Civil SSDA - Flood Assessment & Stormwater Management Report

**Lang Walker AO Medical Research
Building - Macarthur**

Prepared for BVN / 11 May 2022

Response to EES Comments

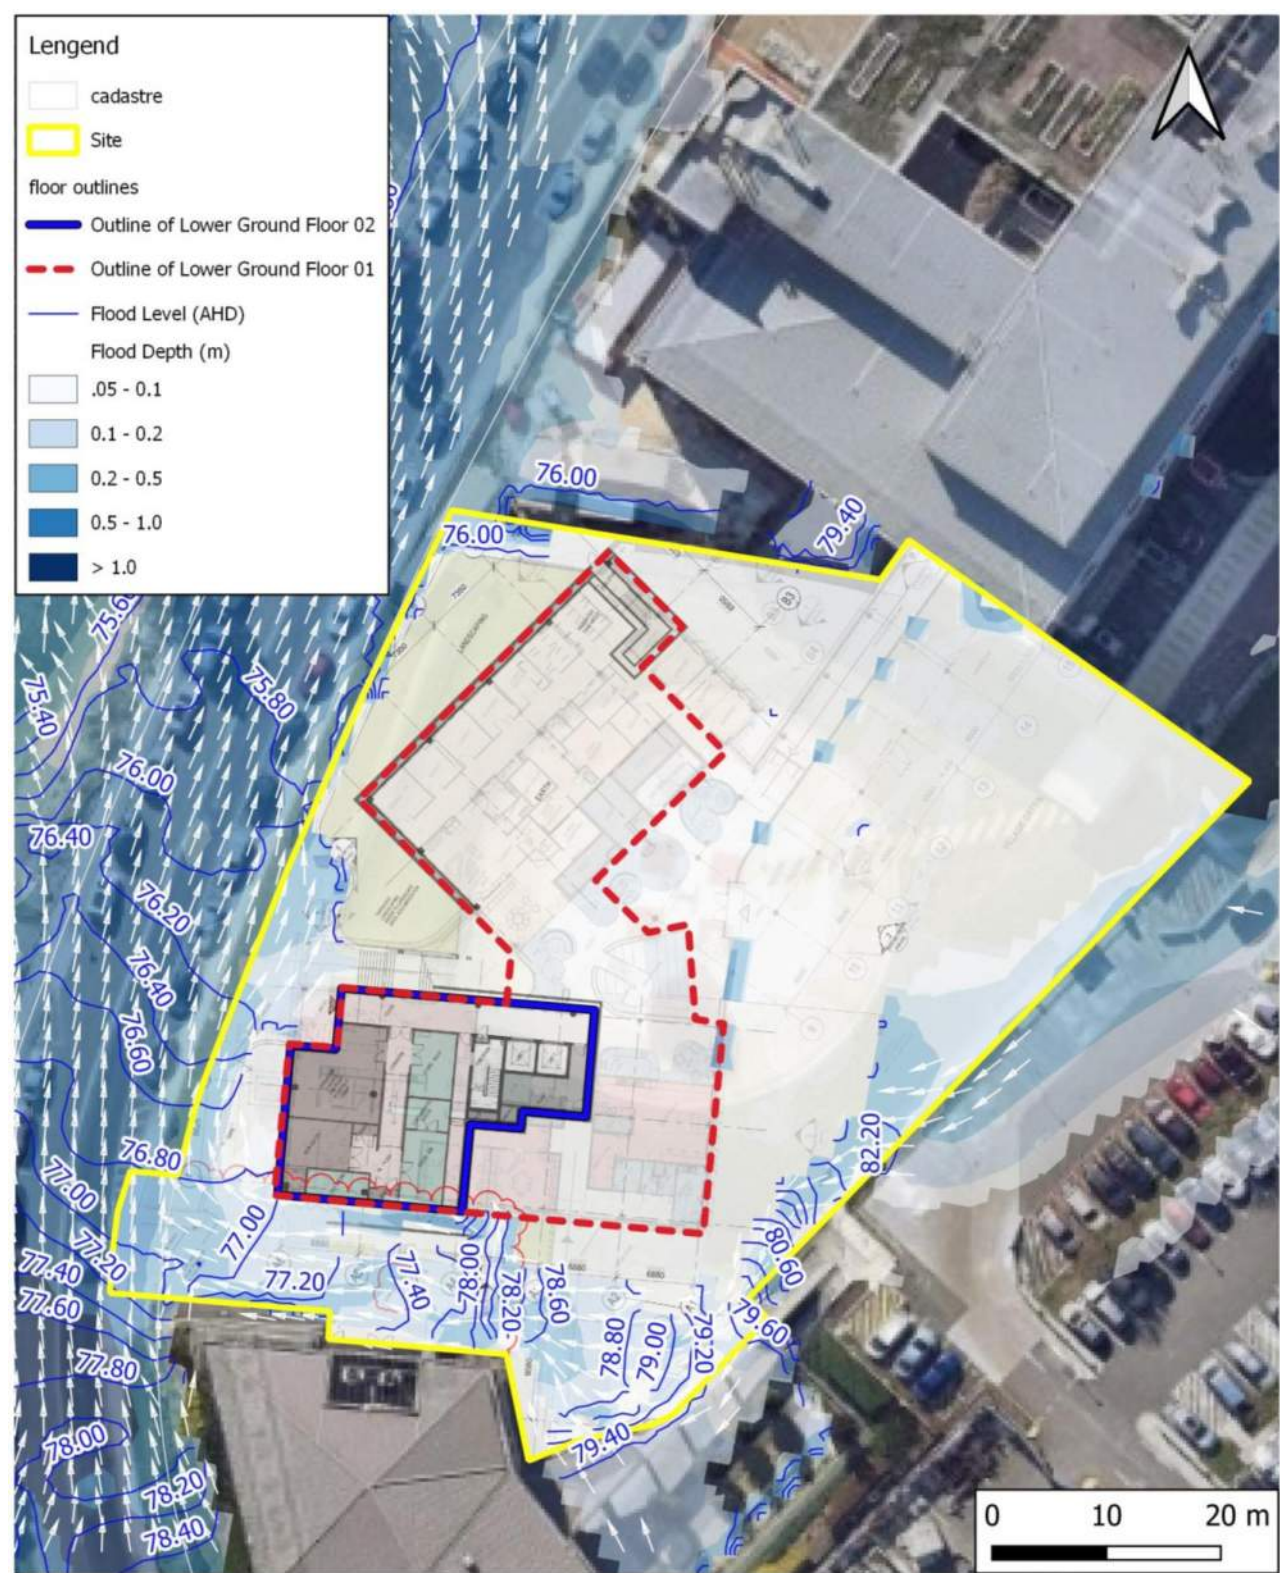
EES Comments	TTW Response
EES has concerns regarding the flood model accuracy. The proposed conditions flood mapping shows flooding inside the building footprint, most notably in Figure 19 of the Civil SSDA – Flood Assessment and Stormwater Management Report Lang Walker AO Medical Research Building – Macarthur (the flood report). The building should be blocked out in the model and no flooding should be present within the building footprint. If the building is not blocked out, impacts will not be properly assessed.	- The proposed building now shown as blocked out in the images as they were in the model. - No flooding is present across the proposed building footprint. (Refer Section 4.5 and Figure 16 & Figure 19). - Figures 17,18 and 19 show flooding below Ground Level, toward the western side of the building, where there this level overhangs Lower Ground Levels 01 and 02. The flooding in this area remains outside the building footprint. The flooding at Lower Ground Floor 01 and 02 are shown in figure 20 and 21 respectively. - Images have been updated to include the building outlines above and below respective floor levels.

Figure 22 – Flood Panning levels (FPLs) Vs. Proposed Finished Floor Levels (FFLs) – Lower Ground 02

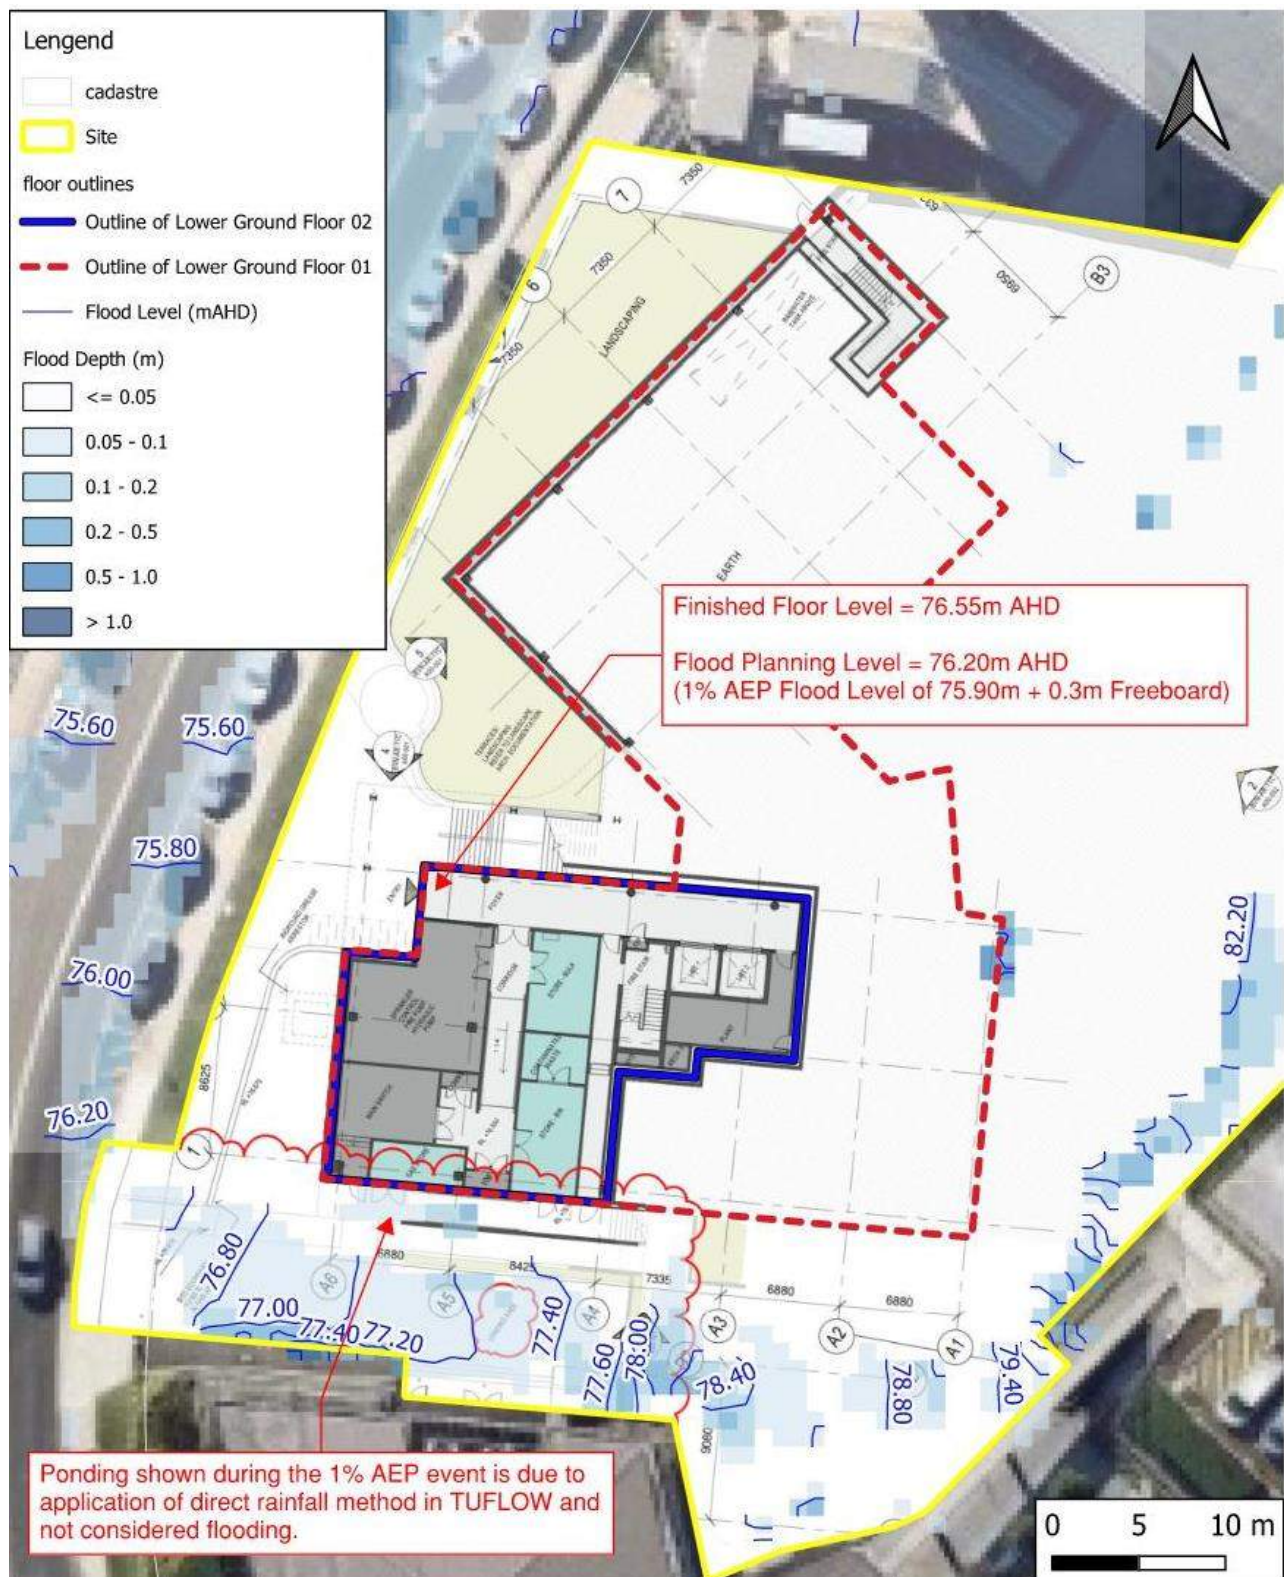
Clarification is also required regarding proposed floor levels and relevant flood levels. Section 5.3.1 of the flood report states that there is insufficient freeboard. It is also unclear where the different building levels are because the only description is "Lower Ground 02" for two separate levels. Levels for all relevant ground floors and associated flood levels need to be provided, for example Level 00 (Village Green). Ideally this should be provided in a table with a description of location and the point location should be marked on a flood map.	- Report has been updated to provide more clarification with regards to floor levels and associated flood levels. (Refer Section 6.0 and Figure 22, Figure 23 & Figure 24) - A table with Flood Planning Levels has been included in Section 6.0 - All proposed floor levels are above the design flood planning levels for the 1%AEP storm event plus 300mm freeboard as per Council's flood planning requirements in Council's DCP.

EES Comments	TTW Response
Section 5.3.1 Flood Levels Adjacent to the Proposed Building's Openings Received architectural plans indicate that the proposed entry level to Lower Ground 02 is 76.10m AHD which is 0.23m above the 1%AEP flood level of 75.88m AHD and 4mm above the adjacent PMF flood level of 76.06m AHD.	Additional Figure 22, Figure 23 & Figure 24 have been provided to confirm that Council's flood planning requirements have been met for all building openings. Refer Section 6.0 of the report for more details.
The Flood report establishes that the proposed Finished Floor Level for the Lower Ground 02 is 76.55m AHD which is above the minimum required FFL of 76.38m AHD (1% AEP flood level of 75.88m AHD plus 500mm freeboard).	Additional Figure 22, Figure 23 & Figure 24 have been provided to confirm that Council's flood planning requirements have been met for all building openings. Refer Section 6.0 of the report for more details.

Figure 25 – Flood Impact Assessment Map (1% AEP Flood event)

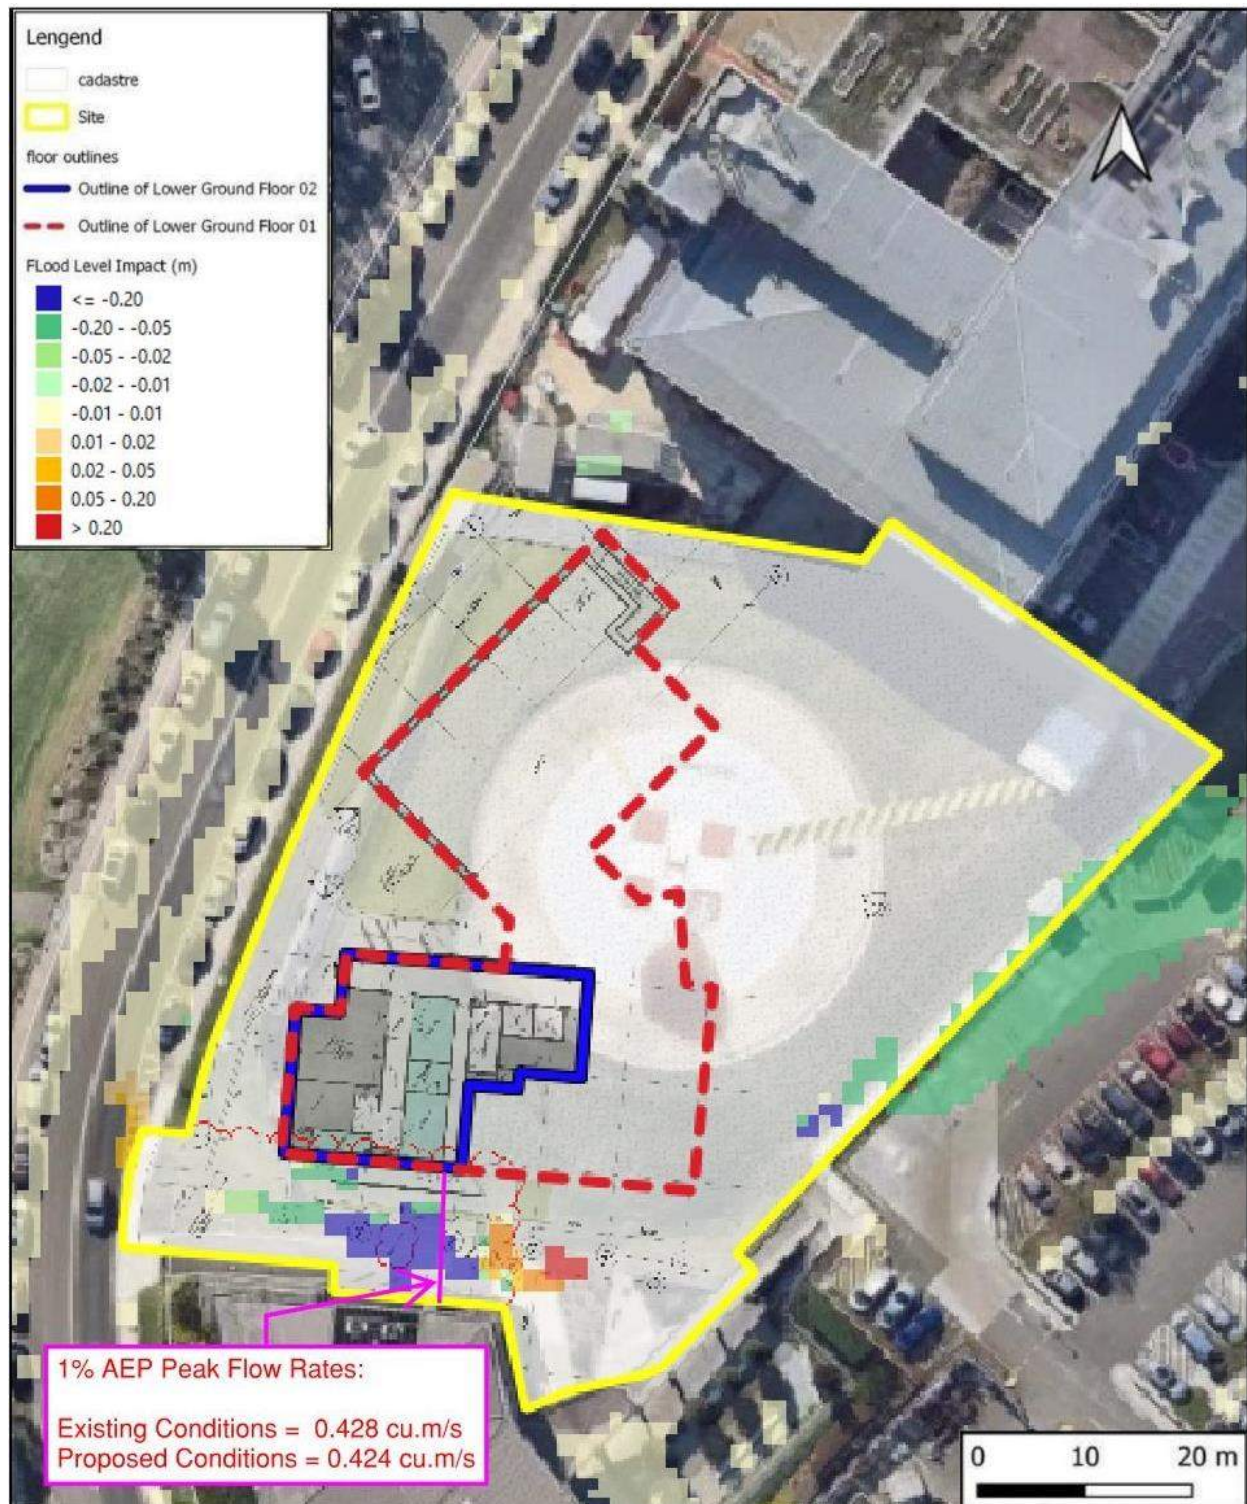
Further detail is required on flood impacts. The Flood Impact Assessment Map for the 1% AEP flood event does not allow assessment of significant impacts because a band of -20 mm to +20 mm has been used. No significant impact is typically considered to be within -10 to +10 mm. The mapping should be revised accordingly. Further, due to the potentially sensitive nature of adjacent land uses (hospital buildings), impact assessment is also required for the PMF event and a corresponding map should be provided.	- Flood impact assessment map with a band of 10mm to +10mm is now shown in Figure 25. The impact map shows no adverse offsite flood impacts beyond ±10mm anywhere beyond the development boundary in the 1% AEP flood event (Refer 6.1). - Flood impact assessment map for the PMF event is now provided in Figure 26. The development does not have any detrimental effect on adjacent buildings during the PMF event.

Campbelltown Council Comments	TTW Response
The site is impacted by overland flow from the car park at the hospital. Council discussed this matter with the proponent's engineers previously, and it was indicated that an overland flow path to the north of the proposed building would be included in the design. This flow path is not evident on the plans, However it is needed and should collect the overland flow and manage its discharge to the pipe drainage system in Parkside Crescent. Overland flows over the footpath, or discharge to the road surface are not permissible.	- The existing overland flow path for the upstream catchment (including the existing car park east of the site) is along the southern site boundary which drains onto the Parkside Crescent as shown in Figure 8 and presented clearly in Figure A1 of Attachment A. - The existing overland flow path has been maintained in the proposed development along the southern site boundary (see Figure 16 and Figure A2 of Attachment A). - The proposed pipe drainage system for the site is designed to cater for storm events of up to 5% AEP (minor event) as per the ARR minor and major drainage system requirements. - Minor storm event for the site is identified based on Table 4.5 of the Campbelltown Council DCP (2015). - The existing pipe network has been assumed to be fully blocked in the 1% AEP and PMF events. This approach provides more conservative results as opposed to the condition where the additional drainage capacity of the pipes is considered. - The existing stormwater pipe network in Parkside Crescent does not have capacity to convey the existing overland flows in major flood events e.g., a 1% AEP flood or greater. - The proposed development does not have any adverse impact on the existing flood levels or overland flow paths outside the development area, including the Parkside Crescent and the footpath. - The Proposed condition slightly reduces the 1% AEP existing overland flow that runs along the southern boundary, refer to Figure 25.
